### REMARKS

### AMENDMENT TO THE DRAWINGS

Corrected replacement drawings for FIG. 4A, FIG. 5A and FIG. 5B are included with this response. Annotated marked up drawings sheets have also been included for the Examiner's convenience.

FIG. 4A

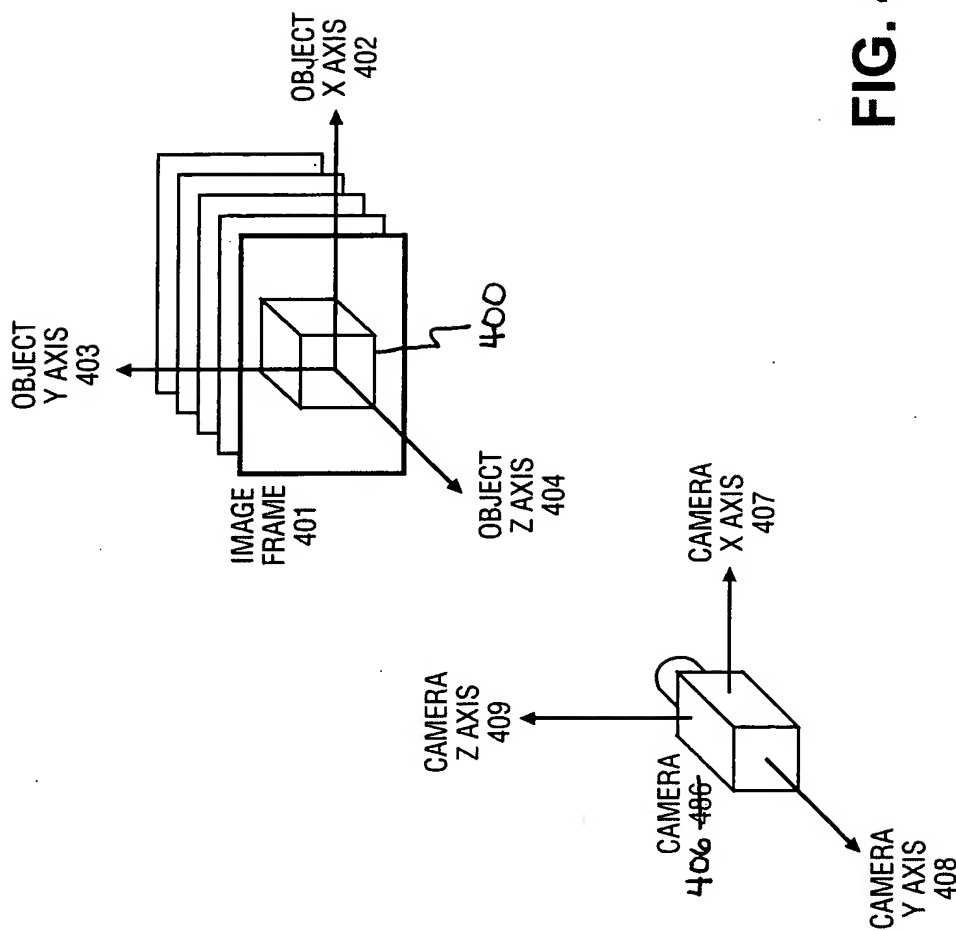
FIG. 4A has been amended to conform to paragraph [0029] of the specification. Specifically, FIG. 4A has been amended to add missing label 400 and amend label 486 to 406. FIGS. 5A and 5B have been amended to conform to paragraph [0035] of the specification. Specifically, FIG. 5A has been amended to add label 500 and FIG. 5B has been amended to add label 510.
